Technical Service Bulletin

| SUBJECT: | | No: TSB-21-42A-011REV2 | |
| MODIFIED HOOD FOR HOOD FLUTTER - 2022 OUTLANDER - REVISED | | DATE: June 2022 | |
| | | MODEL: 2022 Outlander | |

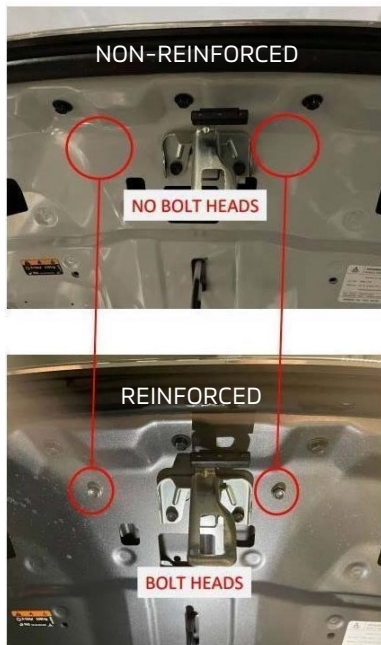
For customers that express concerns with hood fluttering, the hood should be replaced with a new modified hood (65100W080P).

A change in the weather strip from a full clip style attachment to a new style which requires installation over the front lip of the hood, has also been made. The new weather strip (65820W020P) should be installed prior to re-installation of the grill (from original hood).

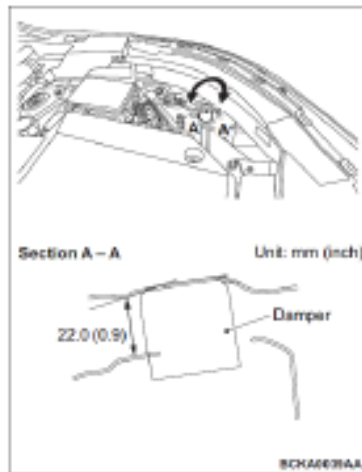
1. Remove the hood panel and other components such as weather strips. **Please note:** the two weather strips on the side of the grill, unless being replaced, do not require removal and will stay affixed to the grill when transferred to the new hood.
2. Pre-set the new hood panel and check whether the dimension and clearance around the hood panel are OK. Check the new hood for the presence of bolts (Refer to Page 1).
 - o Re-alignment needs to be performed according to the workshop manual, if necessary
 - o Prior to presetting the hood panel, the height of hood bumper rubbers must be 24.0mm (1.0 inch) (Refer to service manual P42A-3)

Image 1

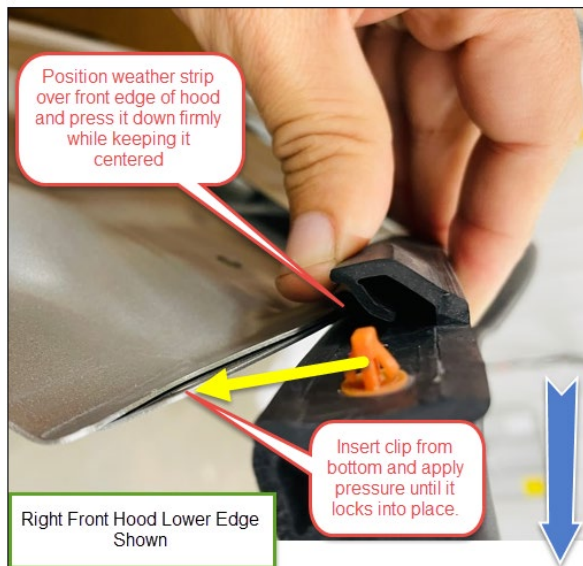
1. Install front weather strip.
2. Install and secure grill with 11 mounting bolts (reuse grill from original hood).

Image 4

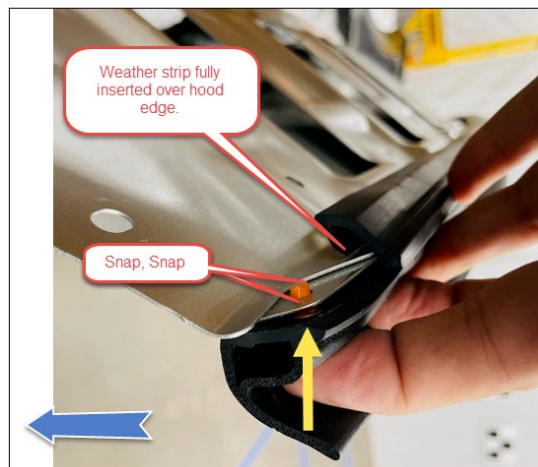
NOTE: For *front end weather strip only installation* the entire grill assembly does not need to be removed (see image 4). Remove mounting bolts from back side of grill and loosen clips on the bottom. Lift grill up and insert weather strip as shown.
